1993 Corvette: Service Bulletin: Transmission "Whine" Noise, Loss of Motion in all Gears, or Missing Clutch Disc Rivets

Model and Year: 1993 CHEVROLET CORVETTE WITH SIX-SPEED MANUAL TRANSMISSION AND 5.7L (LT1) ENGINE (VIN CODE P)

Bulletin Number: 37-71-40

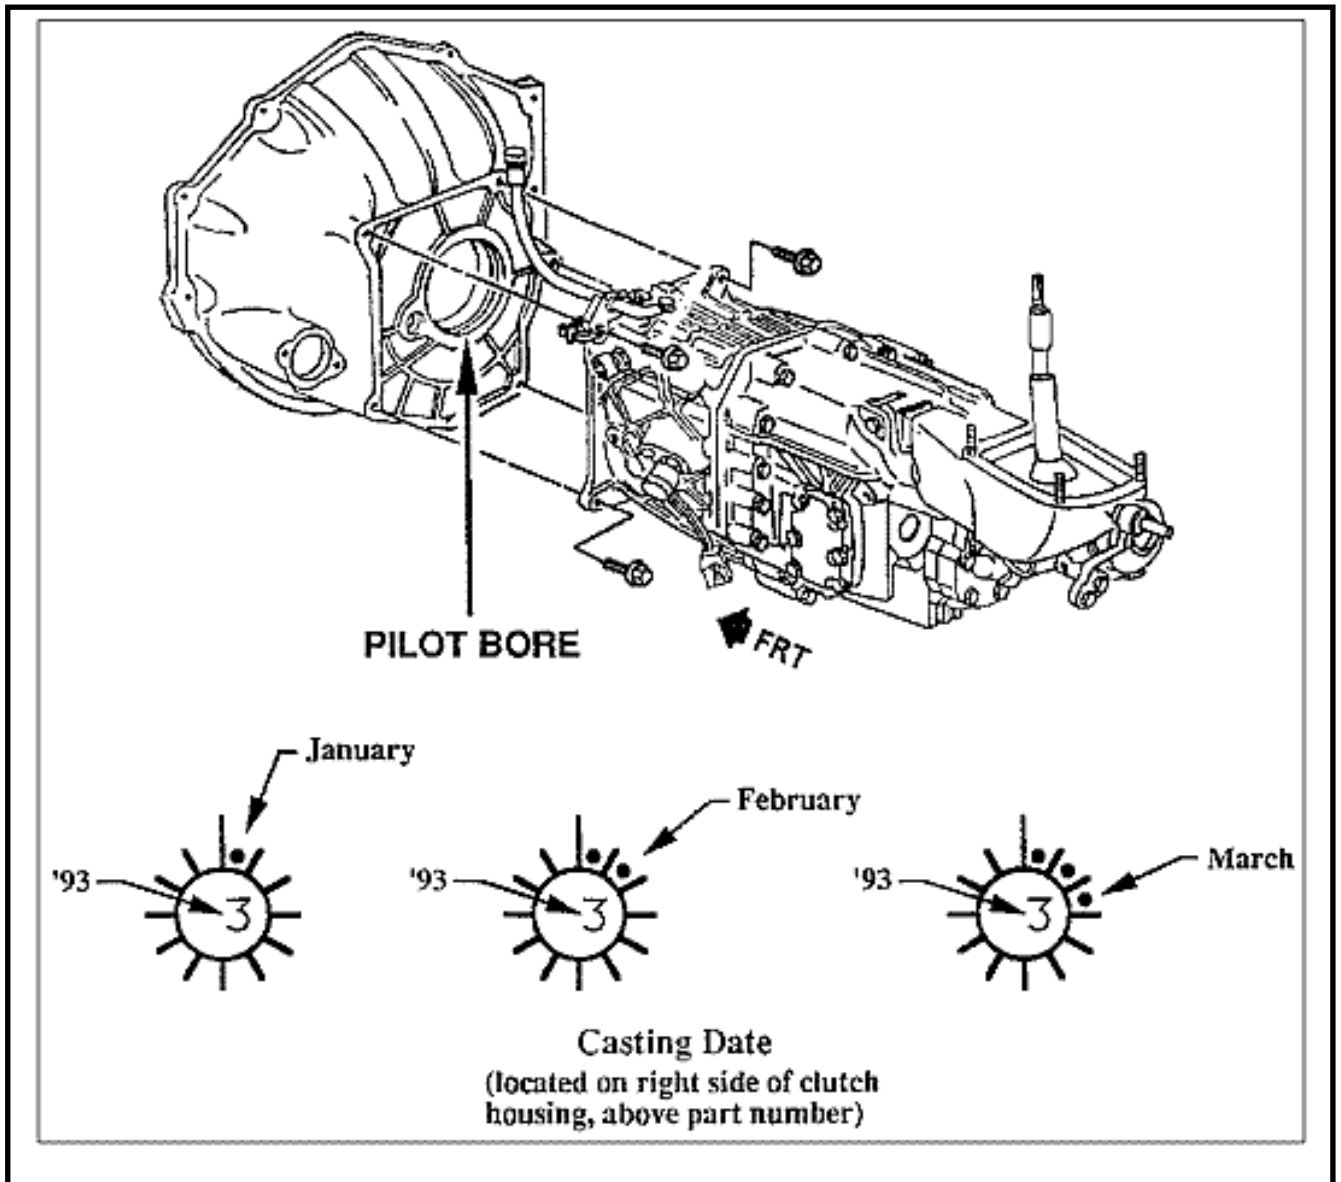
IF THE VEHICLE IS BUILT BETWEEN THE VIN BREAKPOINTS OF 110966 THROUGH 113902 AND THE CLUTCH HOUSING HAS A CASTING DATE OF EITHER "JANUARY, FEBRUARY, OR MARCH 1993", THE CLUTCH HOUSING MAY BE THE CAUSE OF THE CONCERNS. THE CLUTCH HOUSING MAY HAVE A MISLOCATED TRANSMISSION TO CLUTCH HOUSING PILOT BORE. SEE FIGURE.

THIS MISLOCATED PILOT BORE MAY SIDELOAD THE TRANSMISSION'S INPUT SHAFT, THEREBY PRODUCING THE "WHINE" NOISE.

THE ABOVE CONDITION MAY ALSO SHEAR THE RIVETS OF THE CLUTCH DRIVEN DISC CAUSING THE CLUTCH DRIVEN DISC FRICTION FACING TO BE DISENGAGED FROM THE SPLINED HUB.

VERIFY THE SUSPECT CLUTCH HOUSING HAS A CASTING DATE OF EITHER "JANUARY, FEBRUARY, OR MARCH 1993". NOTE: SUSPECT HOUSINGS WILL HAVE NO MORE THAN THREE (3) "DOTS" IN THE CAST DATE. SEE FIGURE.

AFTER ABOVE VERIFICATION, REPLACE CLUTCH HOUSING, P/N 10126448. PARTS ARE CURRENTLY AVAILABLE FROM GMSPO.
